# Access Compliance Report

## Public Rights-of-Way

### (Curb Ramps)

Intersection ID: N/A	Main Street: FINCHER_FARM_RD	Cross Street: N/A	Location: SE
ADA ID: 5293C009AA7B	Ramp Type: PerpDiag	Initial Pass/Fail: Fail	Overall Compliance: No
Codes/Mitigation Info/Possible Solution		Field Measurements/Component Compliance	
Severity Score: 12.5

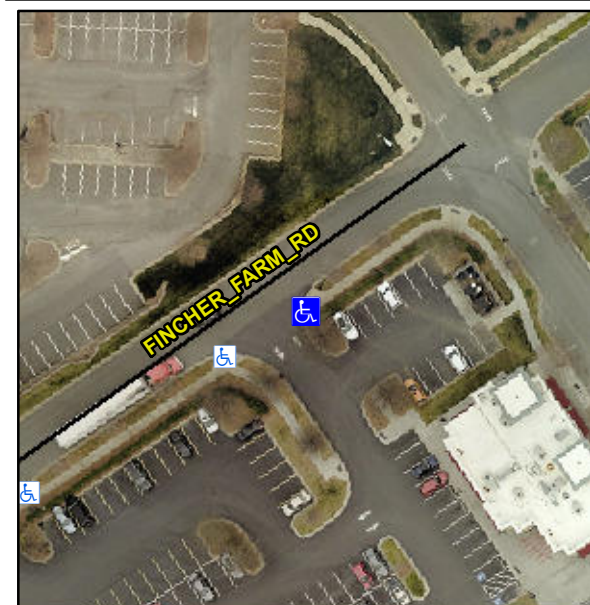
**Not Found, R304.2.2**

Compliance	Description	Data	Compliance	Description	Data
N/A	Ramp Length (in)	67.0	No	Ramp Slope (%)	9.7
Yes	Ramp Width (in)	48.0	Yes	Ramp XSlope (%)	0.6
N/A	Flare Type LT	N/A	N/A	Flare Type RT	N/A
N/A	Flare Slope LT (%)	N/A	N/A	Flare Slope RT (%)	N/A
N/A	Flare Traversable LT?	N/A	N/A	Flare Traversable RT?	N/A
N/A	Landing Length (in)	N/A	N/A	DWS Provided?	N/A
N/A	Landing Width (in)	N/A	N/A	DWS Contrast?	N/A
N/A	Landing Slope (%)	N/A	N/A	DWS Length (in)	N/A
N/A	Landing X Slope (%)	N/A	N/A	DWS Full Width?	N/A
N/A	Landing Curb? (Y/N)	N/A	N/A	DWS Offset (in)	N/A
N/A	Shared Landing?	N/A			
N/A	Gutter Ponding?	N/A	N/A	Gutter Slope (%)	N/A
N/A	Gutter Lip Ht (in)	N/A	N/A	Gutter X Slope (%)	N/A
N/A	Painted X Walk1?	No	N/A	Painted X Walk2?	No
	X Walk 1 Direction	To NW		X Walk 2 Direction	To SW
N/A	X Walk 1 Width (in)	N/A	N/A	X Walk 2 Width (in)	N/A
	X Walk 1 Slope (%)	2.3		X Walk 2 Slope (%)	2.0
	X Walk 1 X Slope (%)	2.7		X Walk 2 X Slope (%)	2.5

**Remove & Replace Curb Ramp With Two New Directional Ramps or Equivalent.**
